## Historic District Commission MEETING AGENDA

## Historic District Commission Staff Report

**Property Address:** 4 N Washington Street

**Application Number:** 2023-924

1 Dover Bldg West Elev Exist 1/8"  
SCALE: 1/8" = 1'-0"

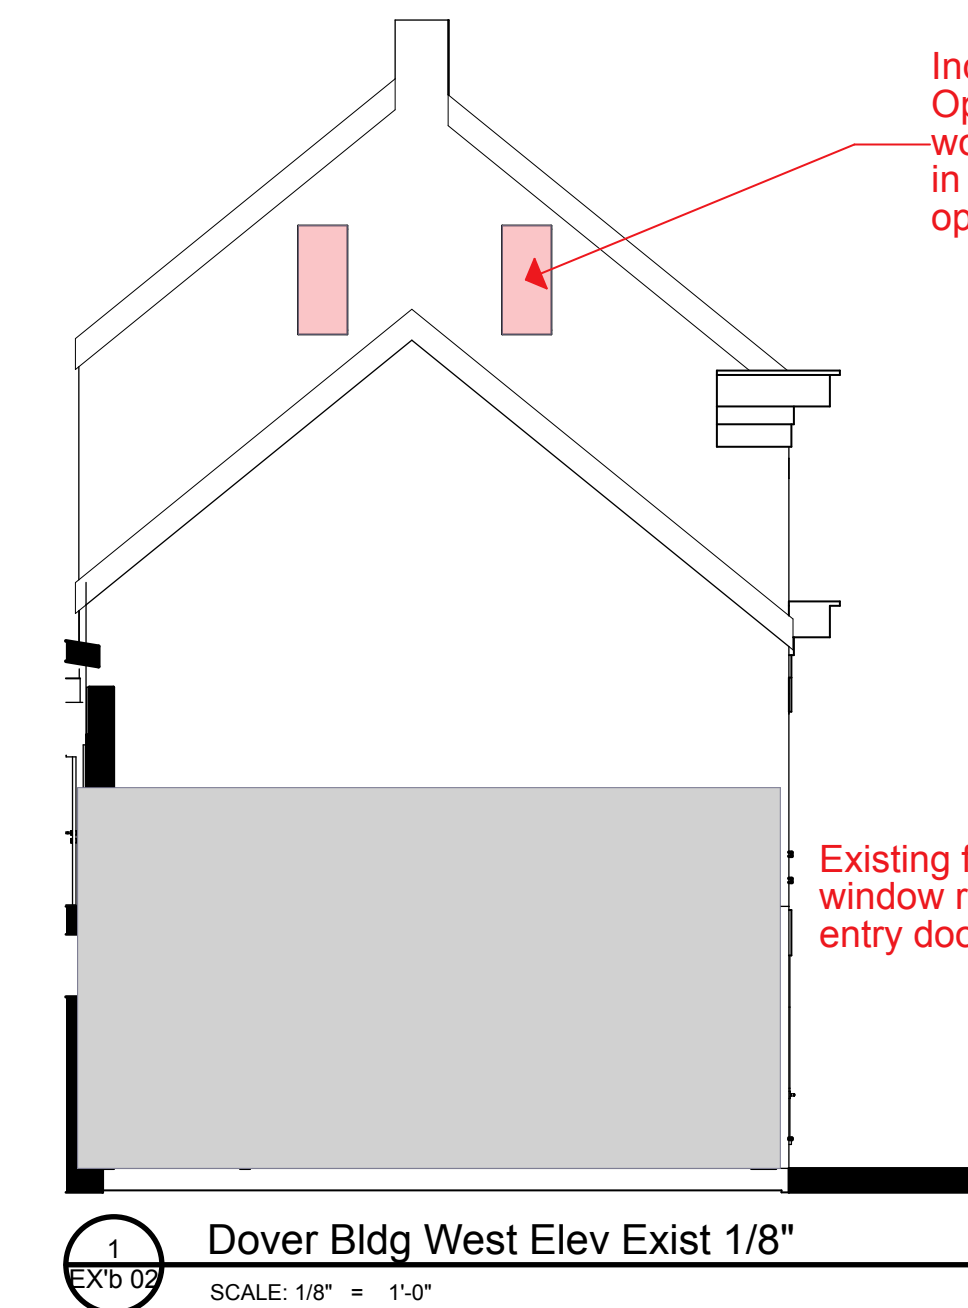
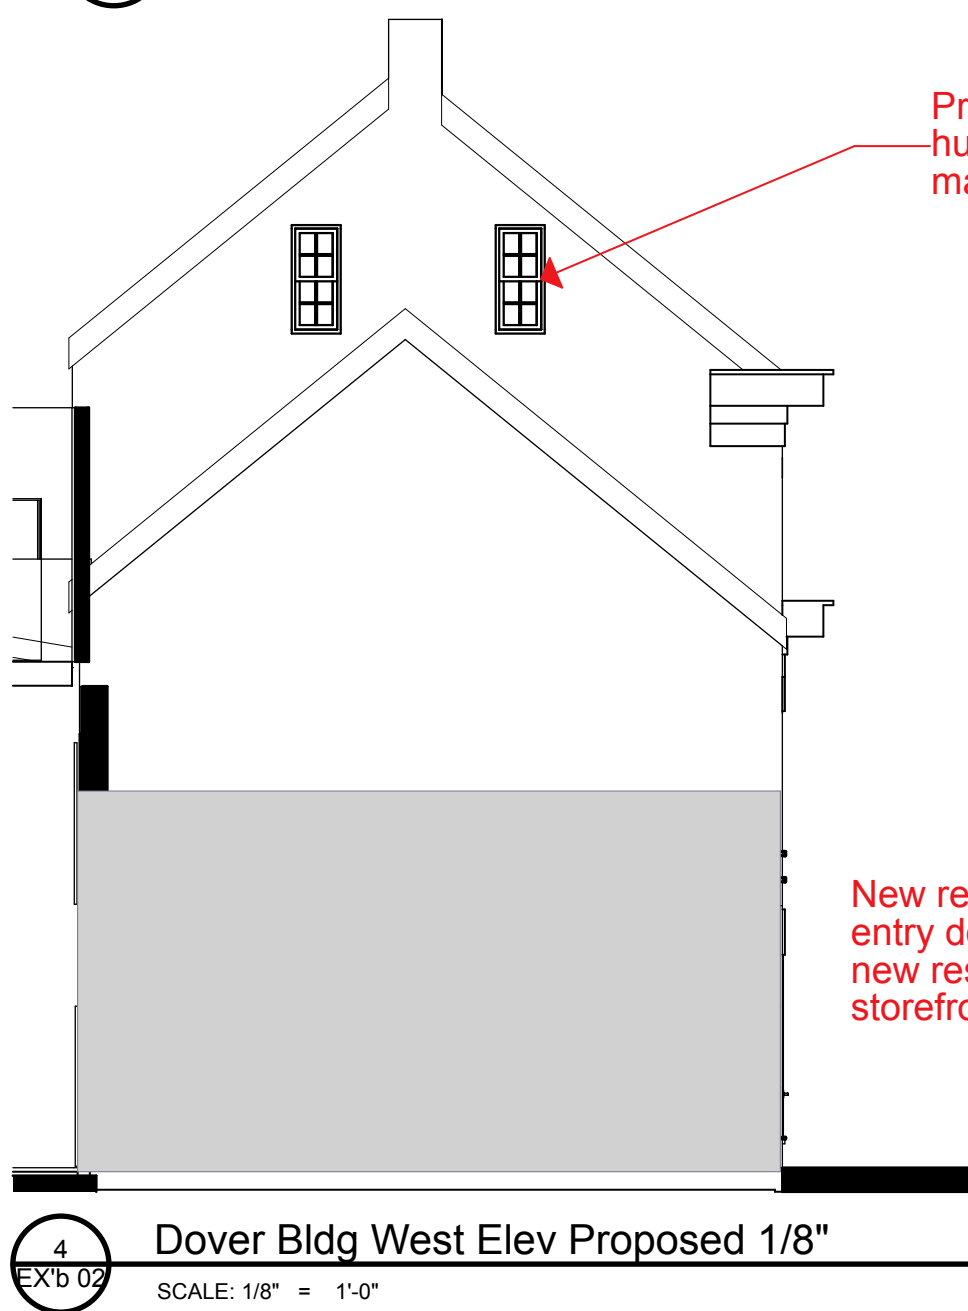
**Analysis** – The reopening of historic windows is consistent with guideline 89c.

**Analysis** – The existing windows on the structure appear to be double hung wooden windows that match the style of the proposed windows.

2 South / Dover Street Elevation, Existing  
SCALE: 1/8" = 1'-0"

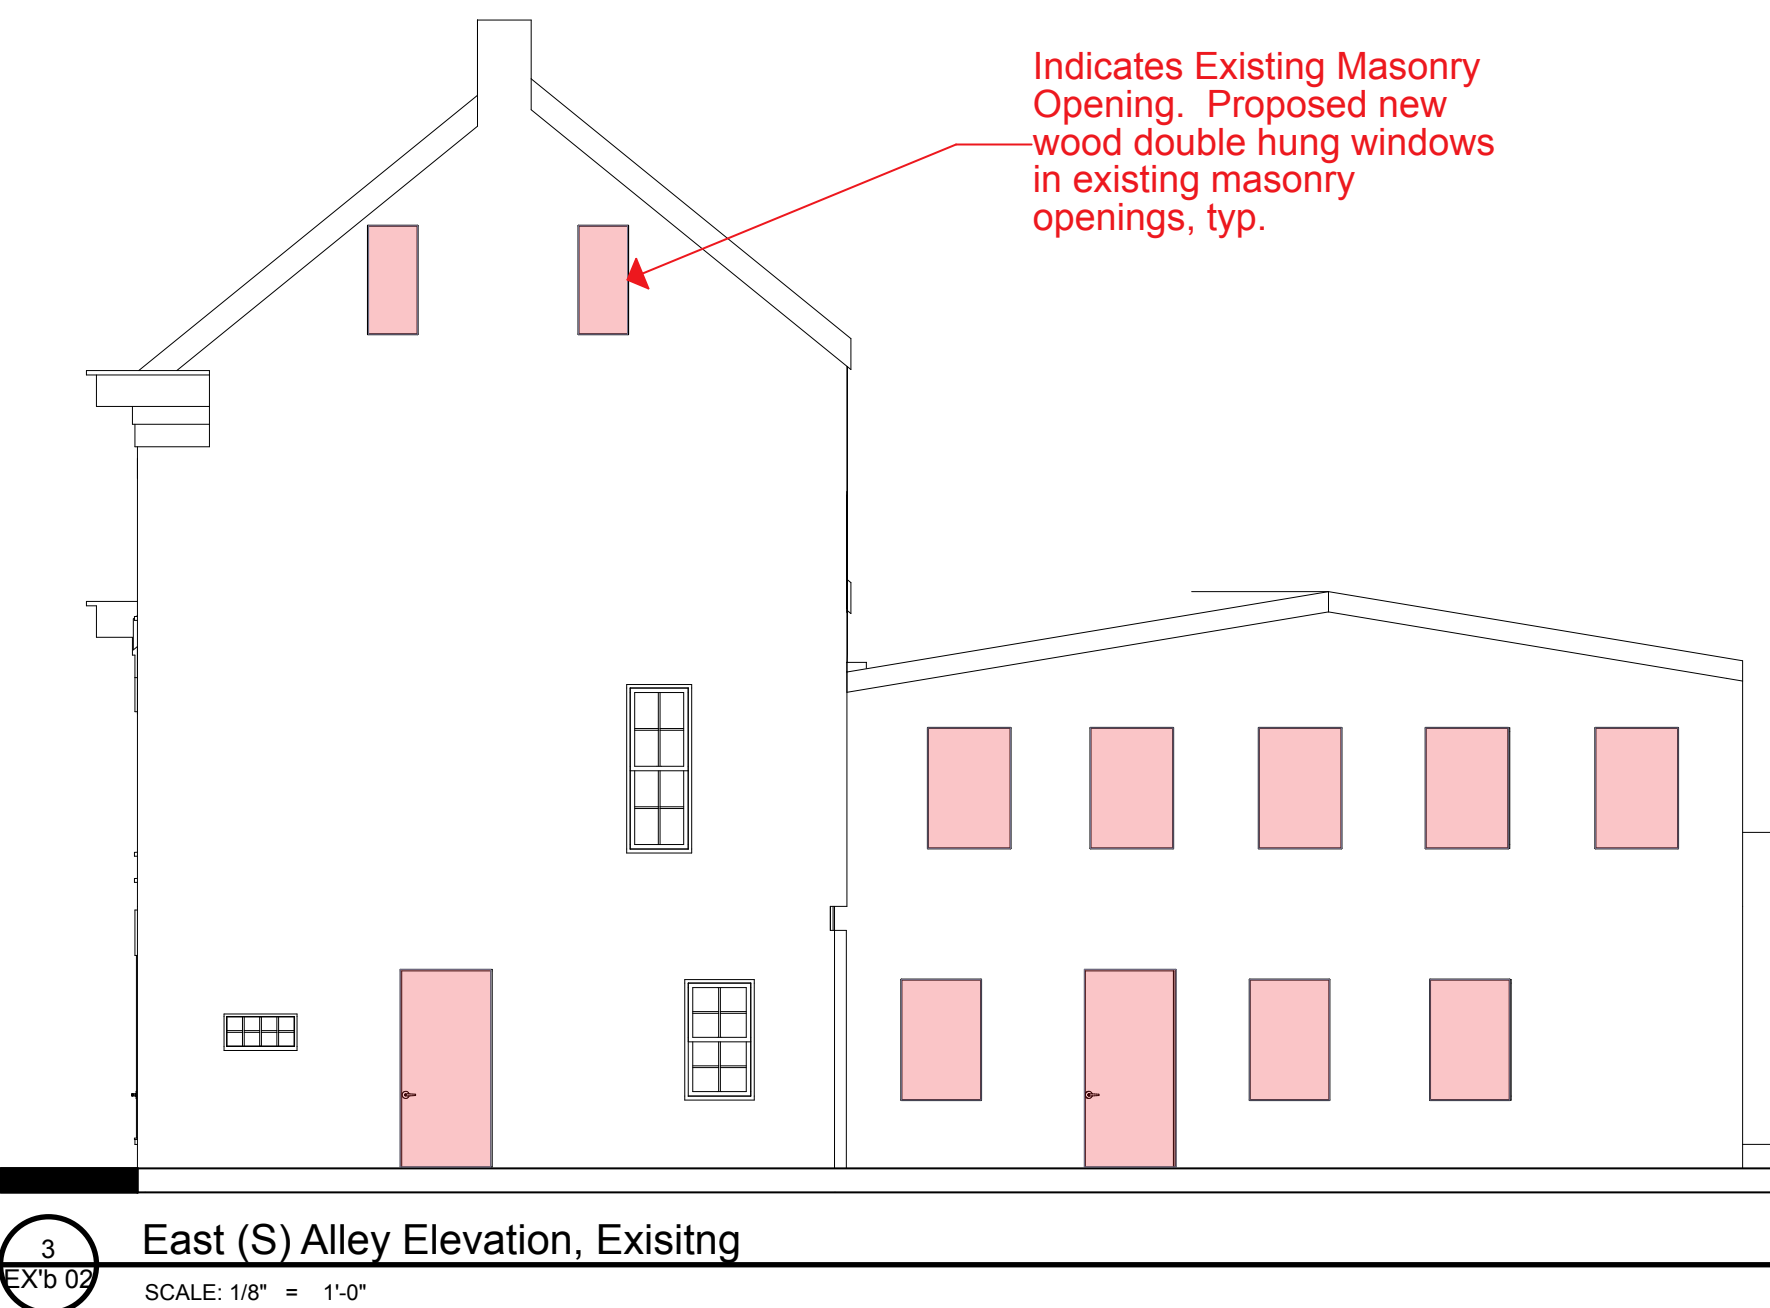
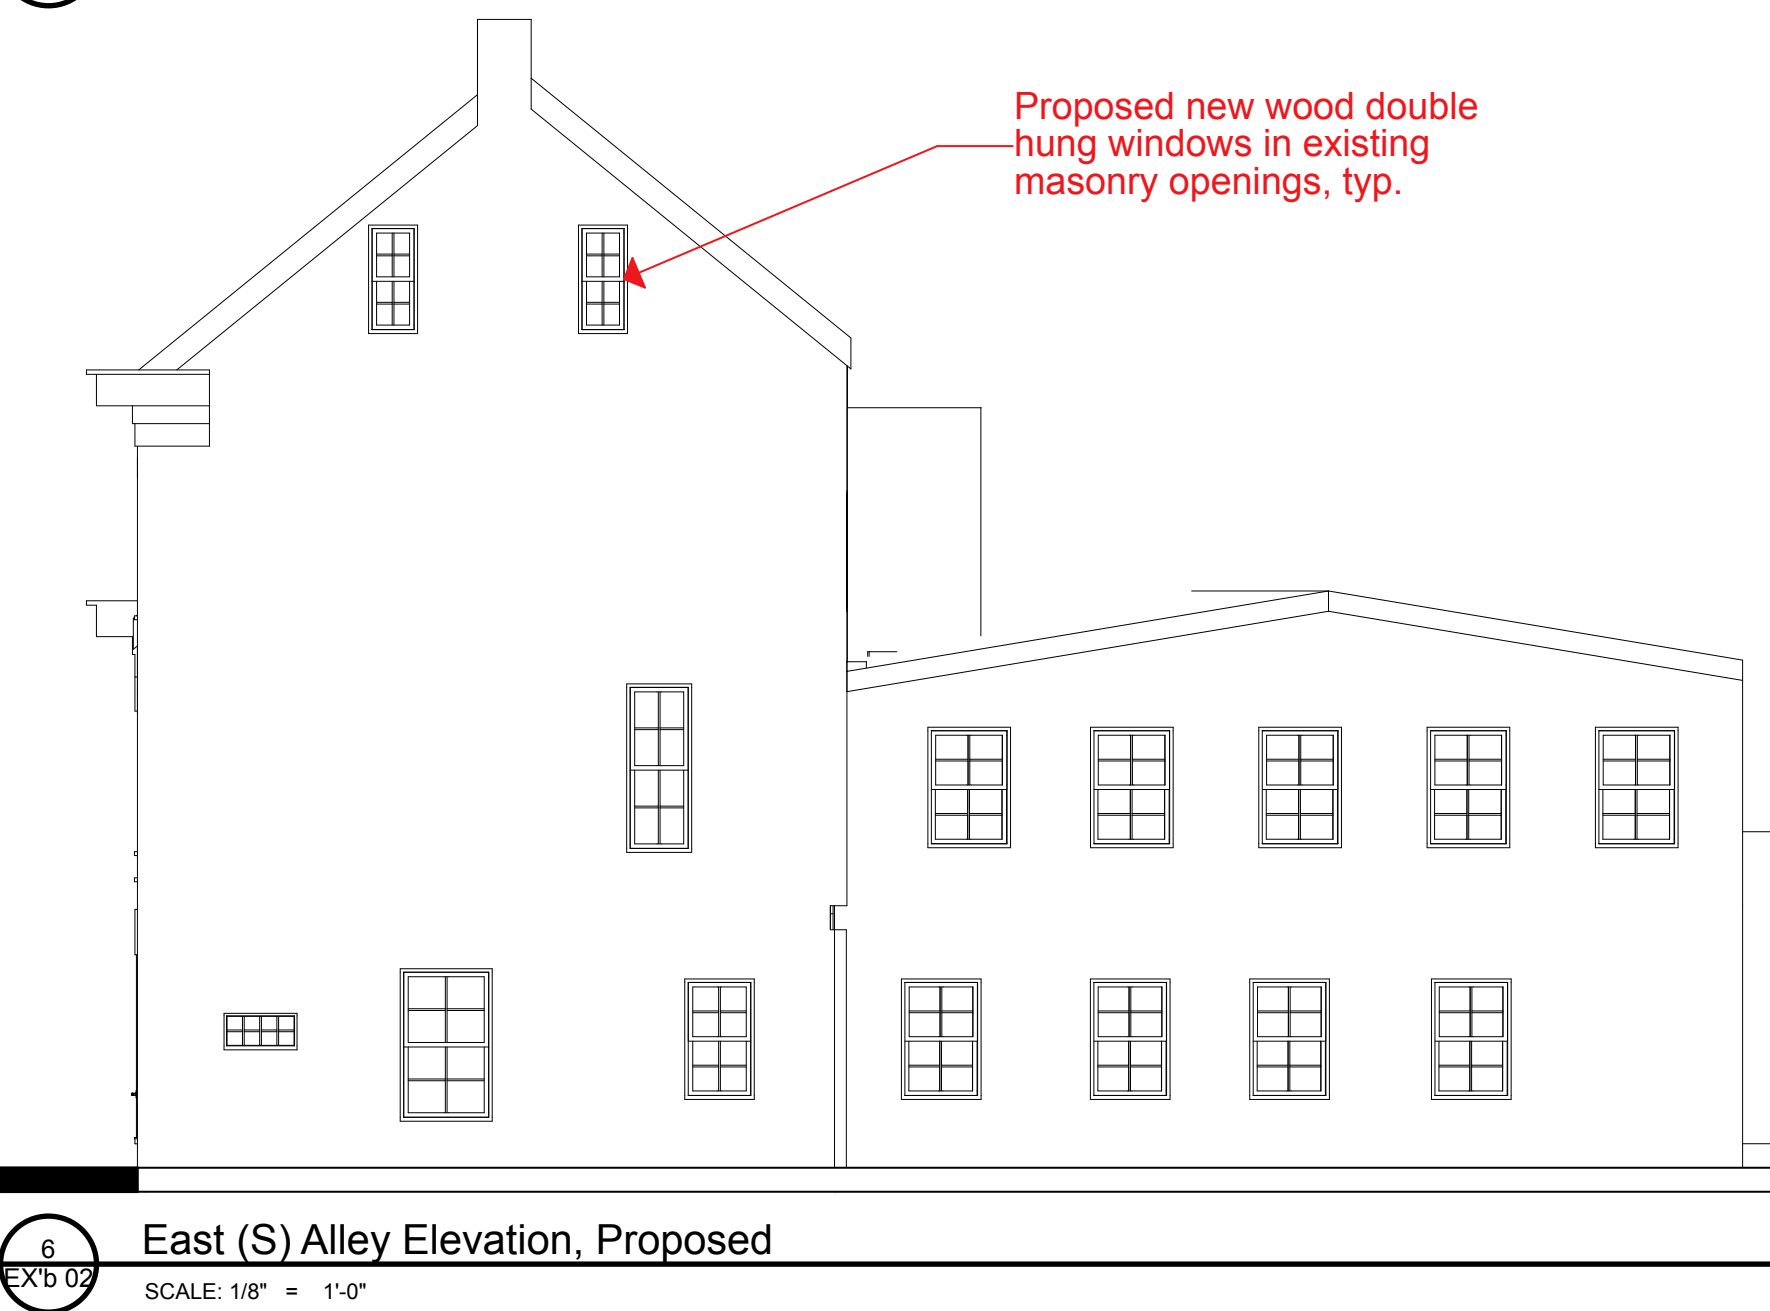
**Analysis** – These two guidelines discourage the addition of new doors on the front façade and converting window openings to door openings. In this case, historic photographs show that this section of the front façade has changed overtime with the addition of the current door and the

addition of the new all glass storefront window. The Commission may request that the new door be located along a side façade in accordance with Guideline 44b.

**Analysis** – The new storefront configuration uses a recessed entrance in keeping with Guideline 81c. The proposed door and transom window are similar to the two existing doors on this structure. Documentary photographic evidence shows that this side of the front façade has been drastically changed over time with the addition of the second door and changes in the storefront windows. There also appears to be a large canopy that historically covered the entire front façade of this structure. The Commission may request that the applicant re-creates this feature based on the historic photographs.

Staff supports a HDC **continuance** of this application. The Commission may request that the applicant explore the feasibility of locating the new entrance door on the alley or the rear façade in keeping with Guideline 44.

1. I move that the Historic District Commission **continue** the application while the applicant explores the feasibility of locating the new door on a side or rear façade.
